Product/Process Change Notice (PCN)

PCN #: PCN_UtLAN_20180209

Product Affected: 749022XXXX

PCN Date: November 9th, 2017Effective Date: February 9th, 2018

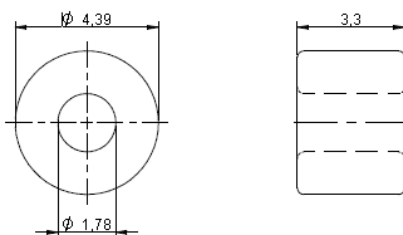
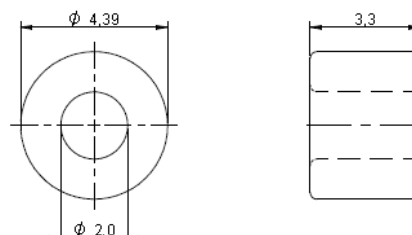
As a production process improvement, the transformer core will be automatically wound. This change will not affect the electrical parameters specified on the datasheet.

For the implementation of this change, the transformer toroid core dimensions will be changed.
